Project File: **Bella Mesa South Filing 1 (PL26-0011 and RE2026-116)**

Douglas County Addressing has completed an additional review of the Bella Mesa South Filing 1 plat and has the following comments:

BELLA MESA SOUTH FILING NO. 1

TRACT C, BELLA MESA FILING NO. 1
SITUATED IN THE SOUTHEAST QUARTER OF SECTION 8,
TOWNSHIP 8 SOUTH, RANGE 66 WEST OF THE SIXTH PRINCIPAL MERIDIAN,
TOWN OF CASTLE ROCK, COUNTY OF DOUGLAS, STATE OF COLORADO.
8.942 ACRES - 93 RESIDENTIAL LOTS - 9 TRACTS
SHEET 2 OF 8

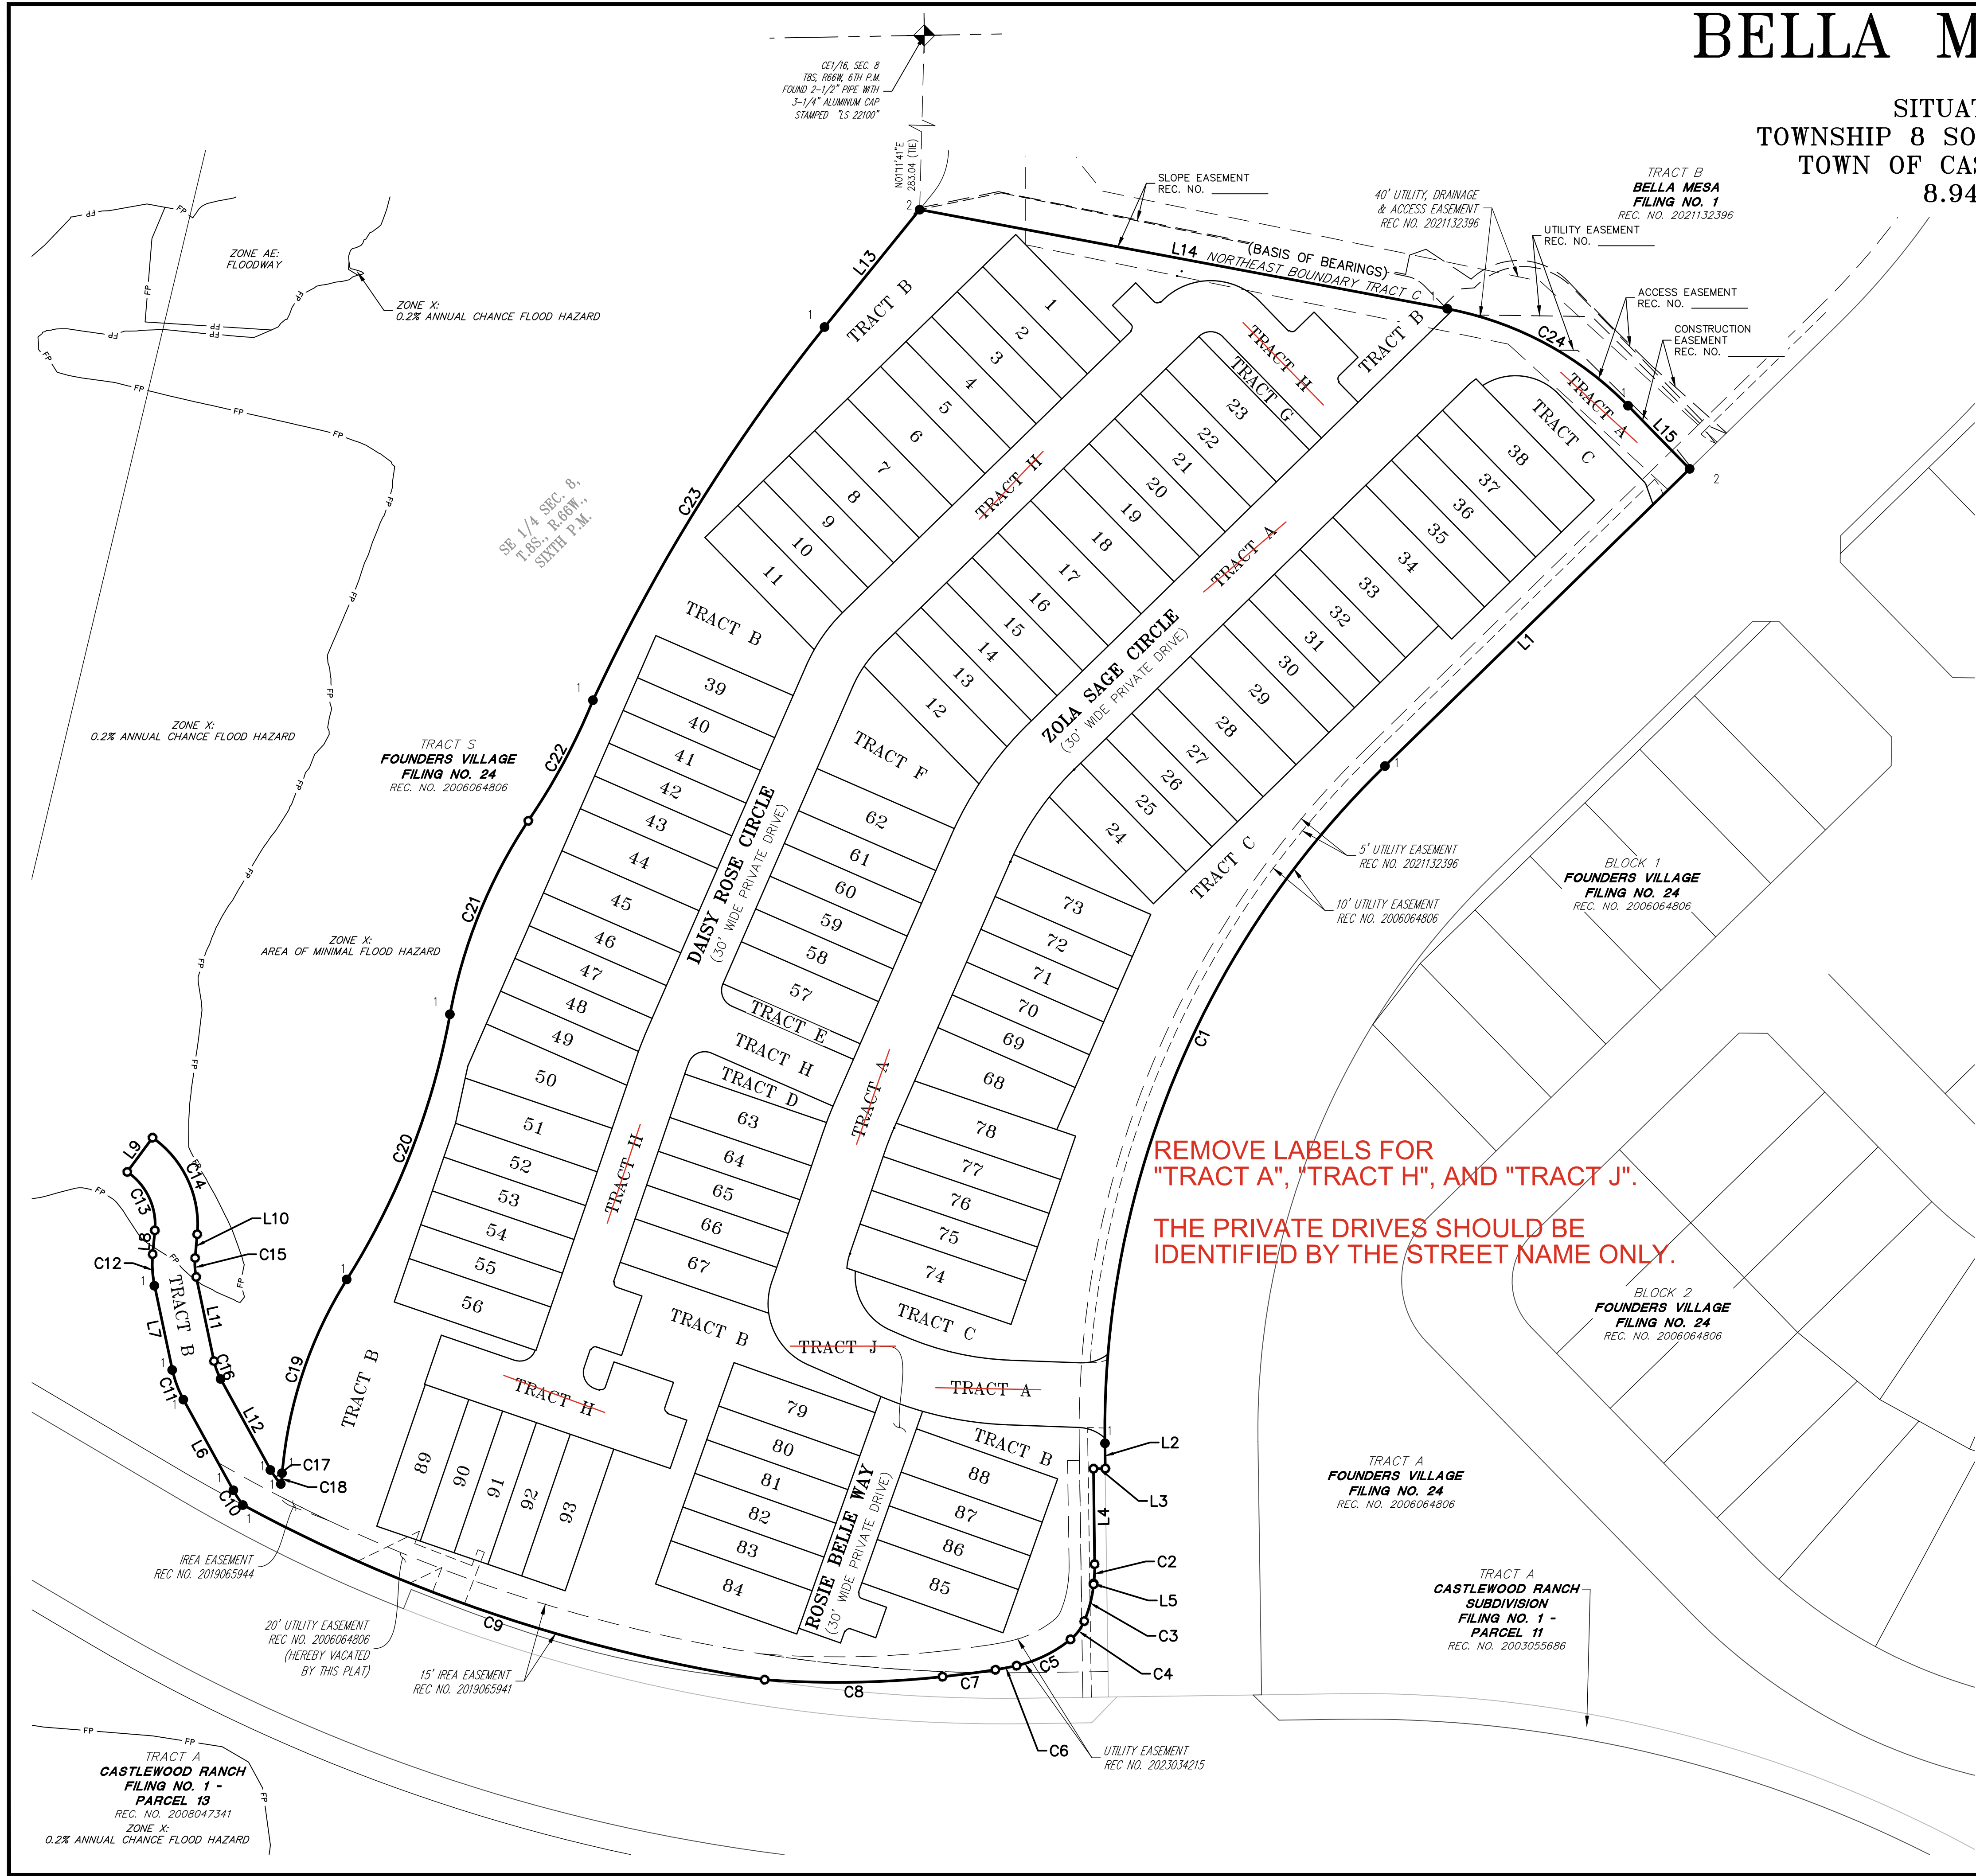
REMOVE LABELS FOR
"TRACT A", "TRACT H", AND "TRACT J".
THE PRIVATE DRIVES SHOULD BE
IDENTIFIED BY THE STREET NAME ONLY.

DETAIL SHEET
PROJECT NO.: PL26-0011
BELLA MESA SOUTH FILING NO. 1 PLAT SHEET 3 OF 8

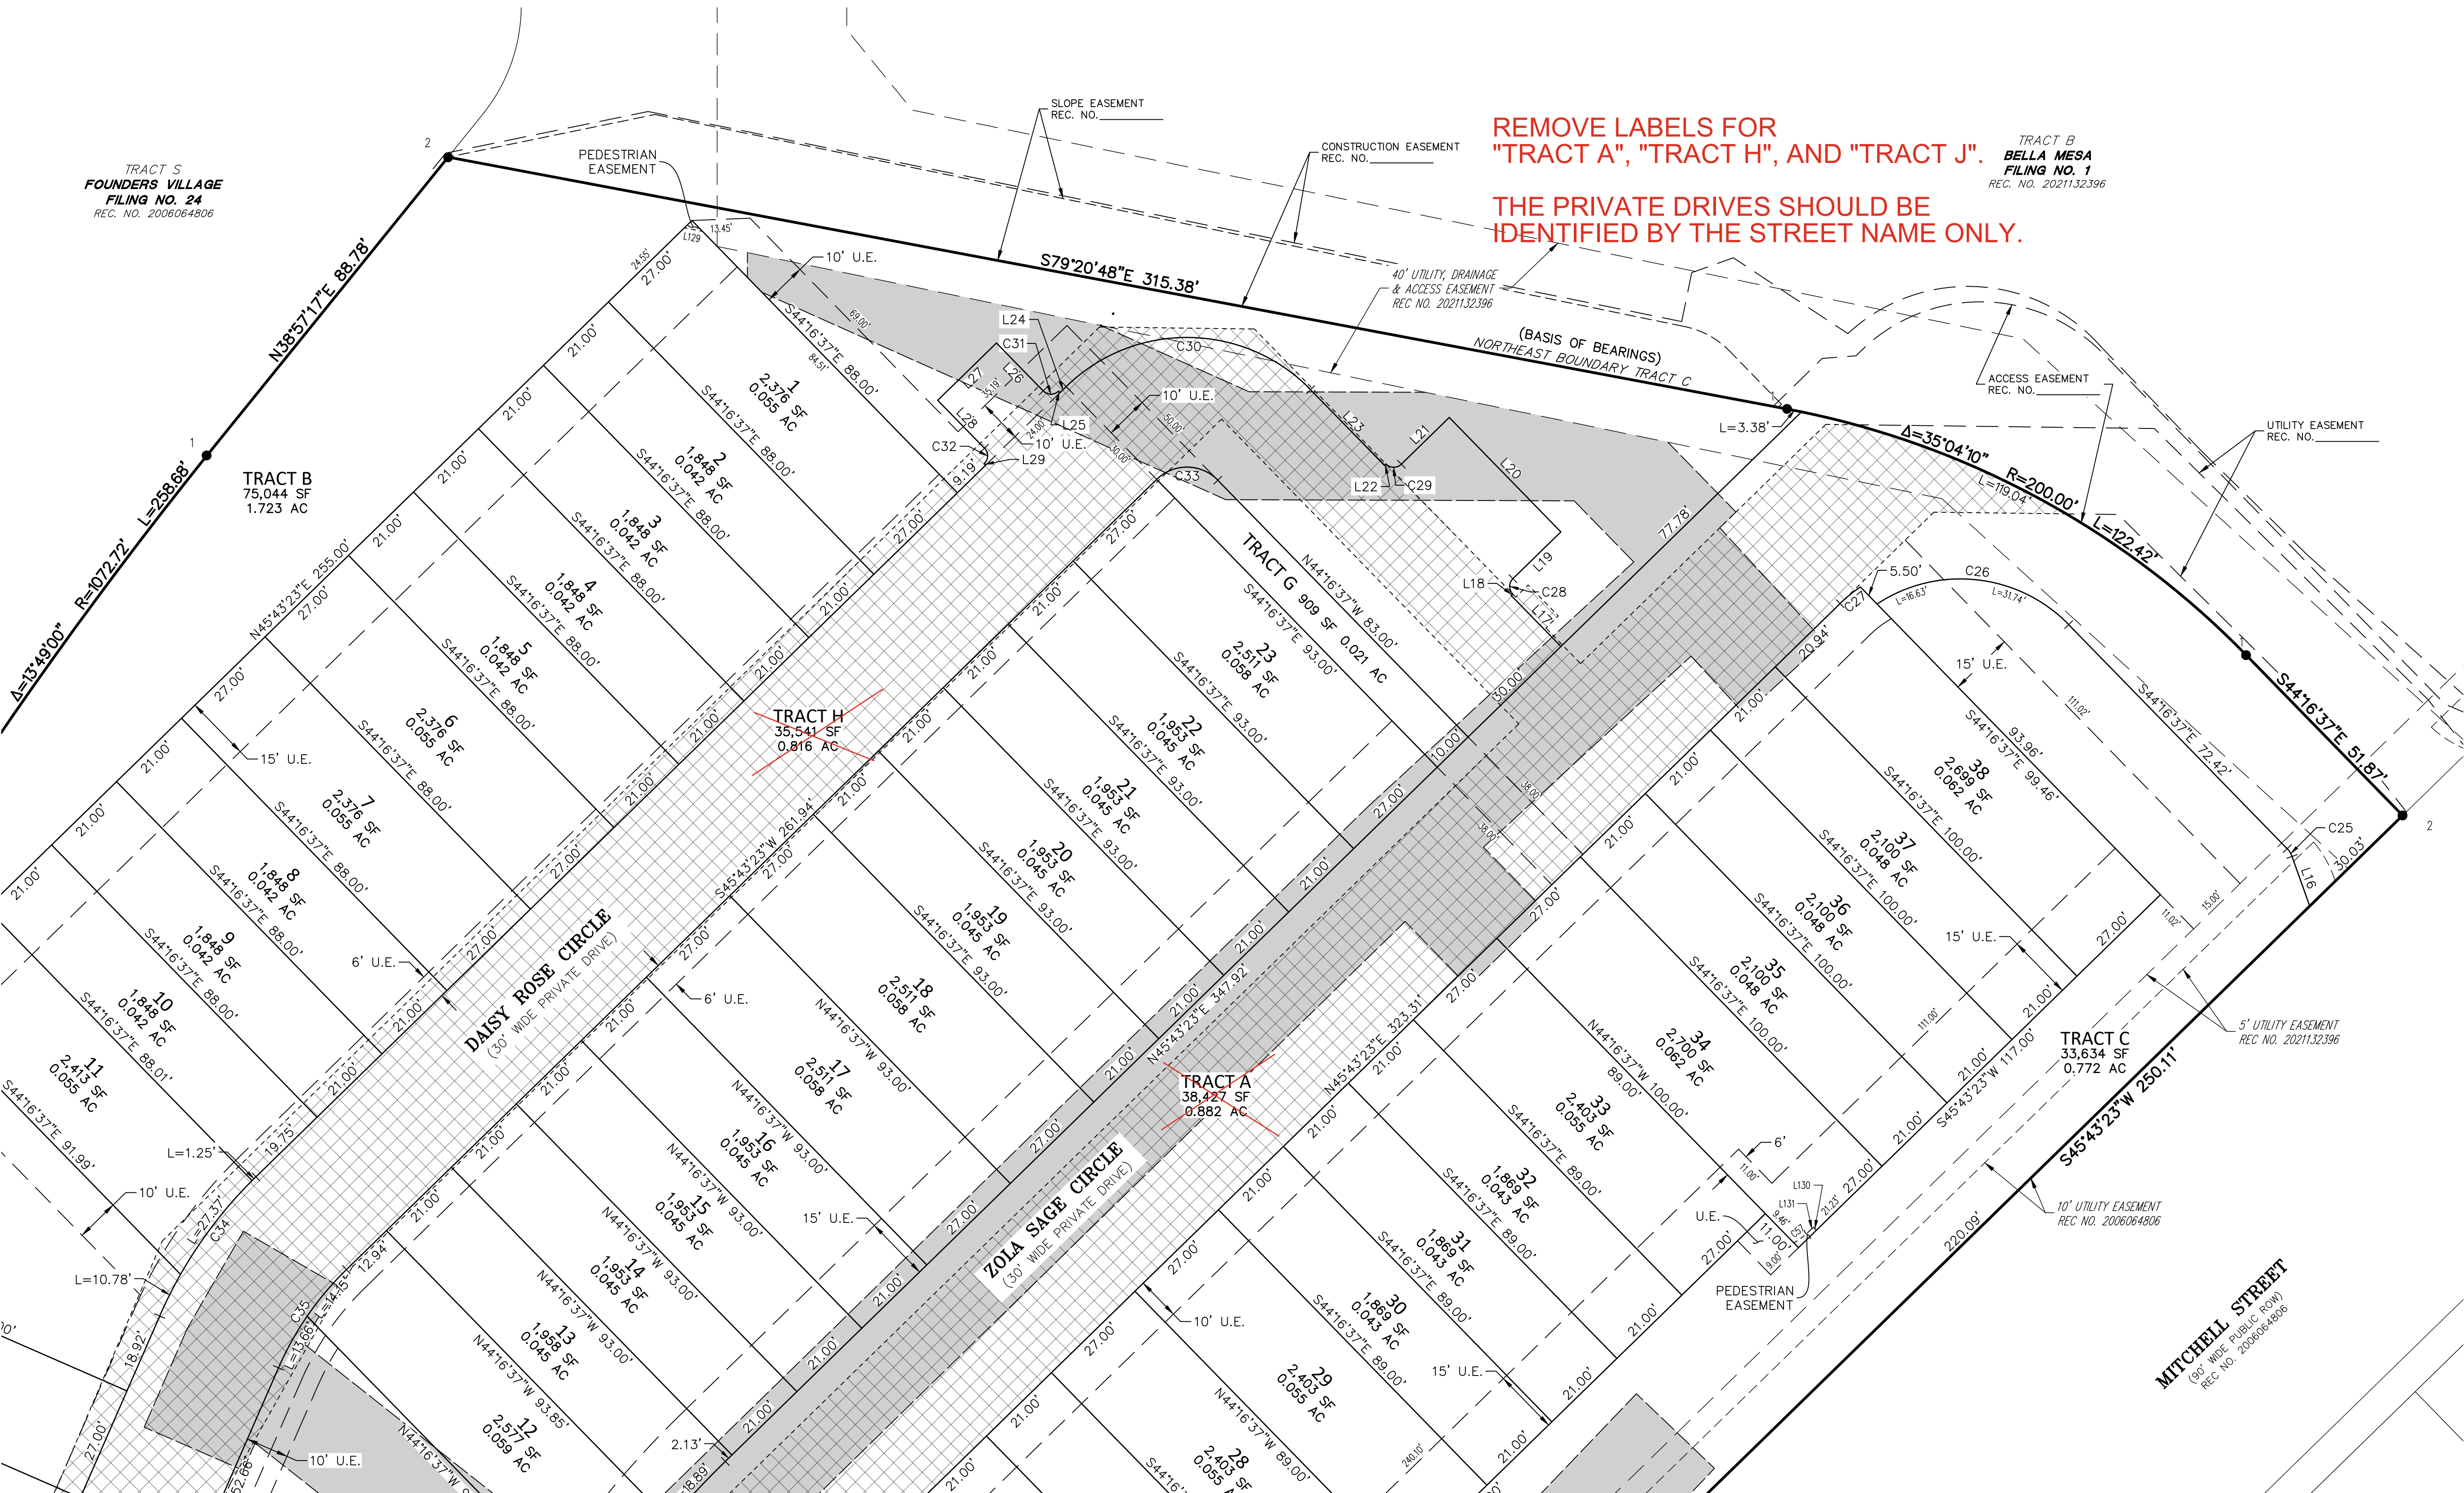
REMOVE LABELS FOR
"TRACT A", "TRACT H", AND "TRACT J".
THE PRIVATE DRIVES SHOULD BE
IDENTIFIED BY THE STREET NAME ONLY.

DETAIL SHEET
PROJECT NO.: PL26-0011
BELLA MESA SOUTH FILING NO. PLAT SHEET 4 OF 8

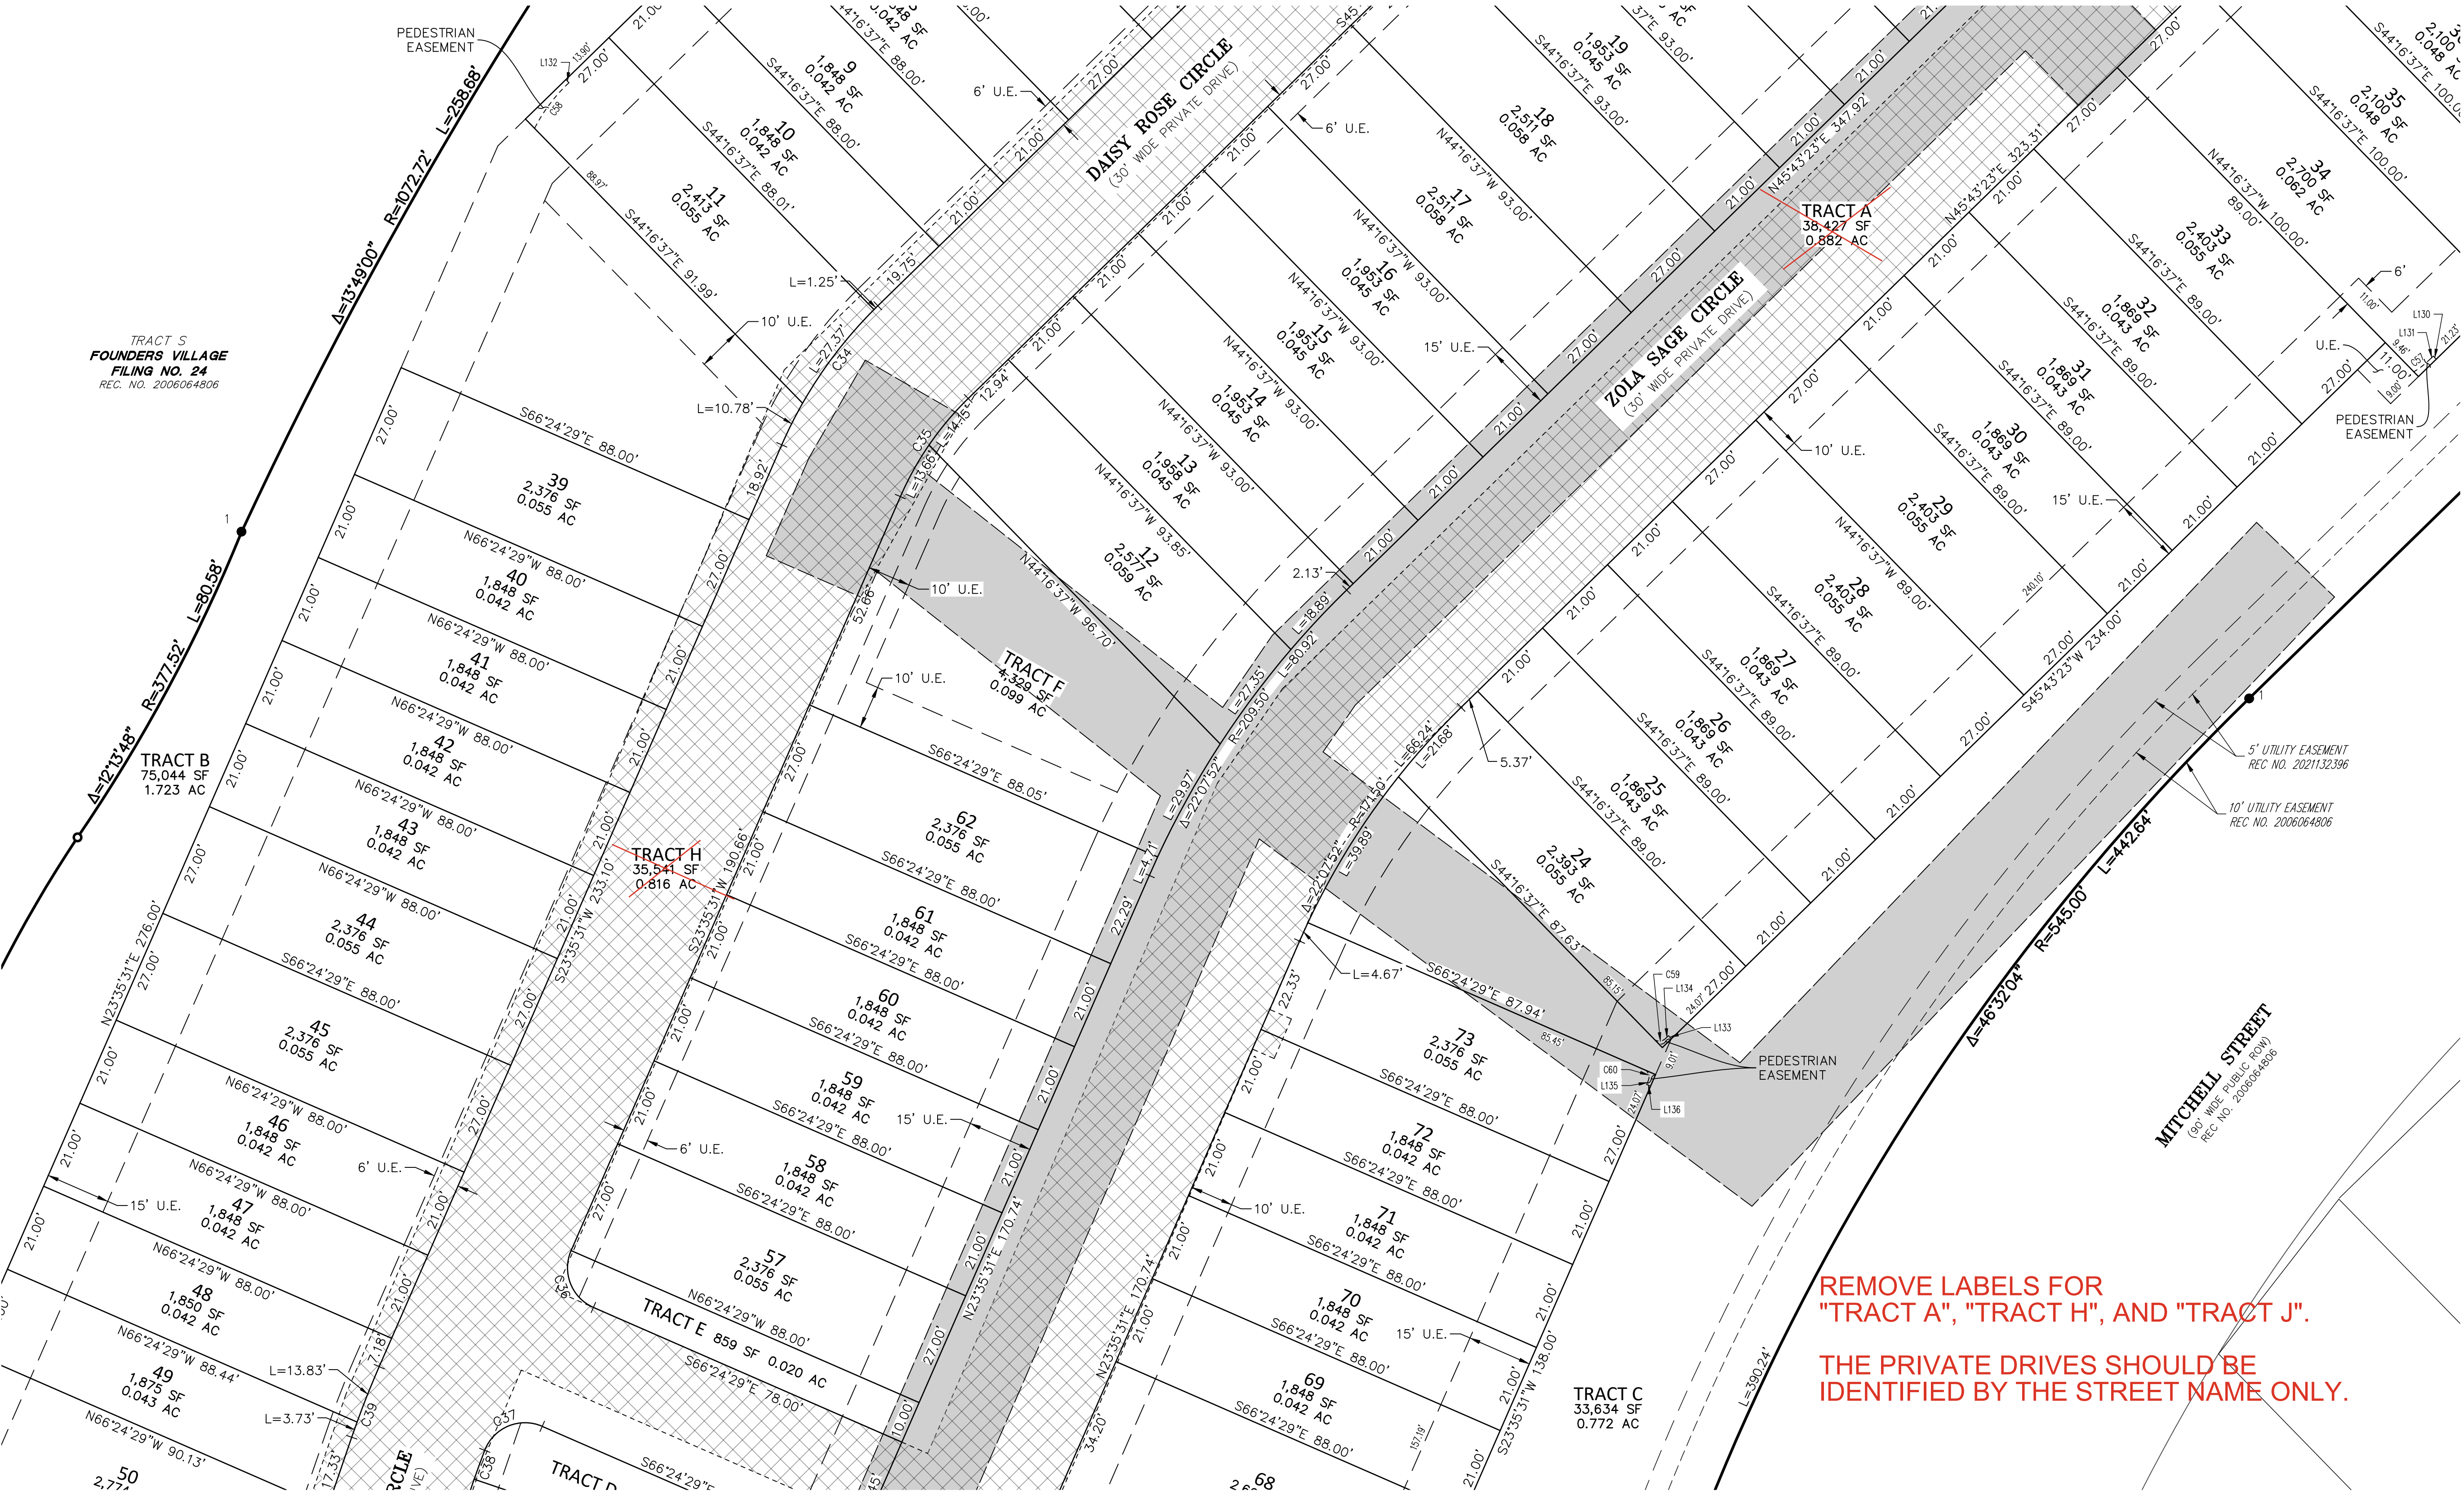
REMOVE LABELS FOR
"TRACT A", "TRACT H", AND "TRACT J".
THE PRIVATE DRIVES SHOULD BE
IDENTIFIED BY THE STREET NAME ONLY.
